# A NORTHERN LIGHTS SOUND ENCLOSURE ASSEMBLY ADDENDUM PAPER

The following notice effects the following Sound Enclosure Assembly Instructions:

- M673L3 05-78010
- M773L3 05-78610
- M843NW3 05-73110
- M844W/LW3 05-70010
- M864W3 05-78720
- M944W3 05-01200

SHOWN BELOW IS THE INTERIOR VIEW OF A TYPICAL SOUND SHIELD REAR PANEL. APPEARANCE MAY VARY DEPENDING UPON GENSET MODEL.

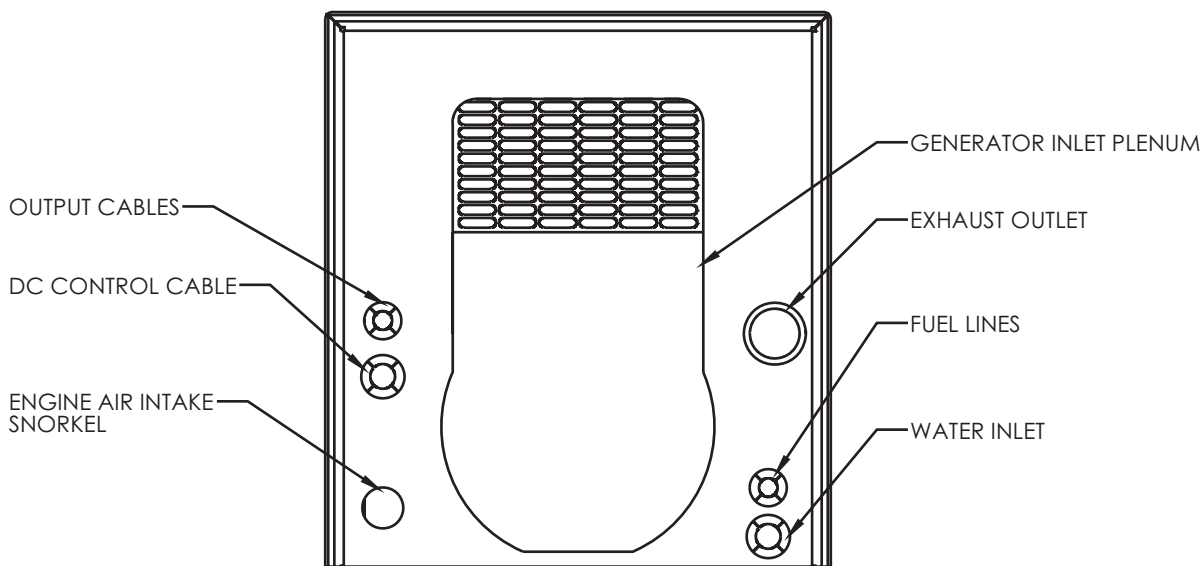
**REMOVE FOAM PLUGS AT LOCATIONS AS SHOWN BELOW.**

**NOTE: SOME LOCATIONS CONSIST OF TWO LAYERS OF SOUND FOAM. TWO PLUGS MAY BE PRESENT AND MUST BE REMOVED BEFORE PANEL INSTALLATION.**
